JULY 2015

OBSOLETE RACK MOUNT PULL-OUT SHELVES, DRAWERS AND SHELF (BULLETINS P20 and DACCY)

Changes effective immediately

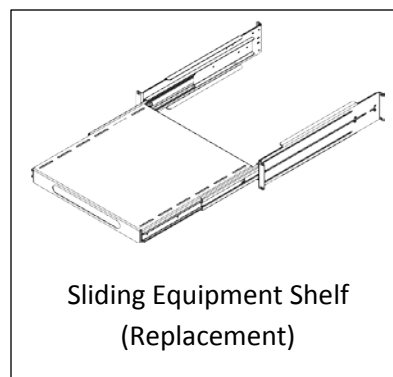
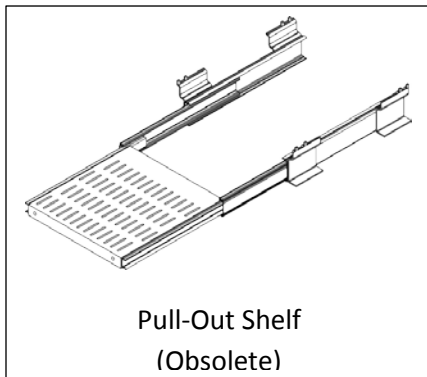
Dimensions: There are slight dimensional differences between the obsolete and replacement shelves. These include width, length and shelf pull-out distance.   See table below for details.

Shelf Surface: The obsolete shelves were perforated. Replacement shelves are solid mild steel.

Mounting: The obsolete shelves mounted on the rear leg of the rack angles. Because of this, the options for rack angles to mount to were limited, as well as the rack angle spacing. The replacement shelves mount to the front leg of the rack angle which makes them more universal--fitting any rack angle, and they are fully adjustable for rack angle spacing. Truly a better option for the customer.
